Recommended Type 1 and Type 2 TLV Usage

The question was how to use TLVs when Type 1 or 2 PSE is connected to Type 3 and 4 dual-signature PD. So, my review is addressing that use case. The use case in which Type 1 and 2 is connected to PD Type 1 and 2 is addressed in clause 33.

Figure 79-3—Power Via MDI TLV format

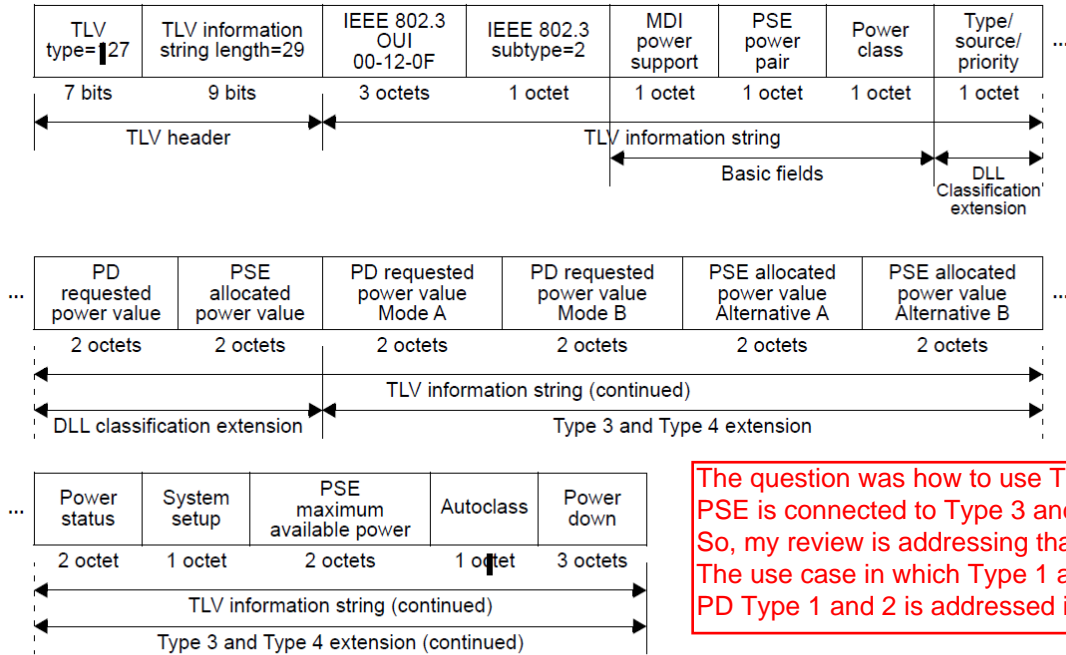
If the use case is Type 1 and 2 PSE is connected to dual-signature PD then if the device generating the TLV is a PD Type 3 or 4 then you must use it per the table. See 79.3.2.6.c. I believe these should stay unchanged as well.

The PD is dual-sig PD and it is Type 3 or 4 PD so the PD knows if this field need to be set to 1 (isolated loads) or 0 (not isolated loads). Not clear what you are trying to block by proposing this option. I believe it should be unchanged as well.

Type 3 and 4 dual-signature PD can't be Type 1 and Type 2 PD when connected to Type 1 and 2 PSE. They are still Type 3 and

The question was about new TLV fields used by the PSE Type 1 and 2 when connected to dual-signature PD. It is not clear why you have addressed PD TLV fields while the question was about PSE related TLV fields?
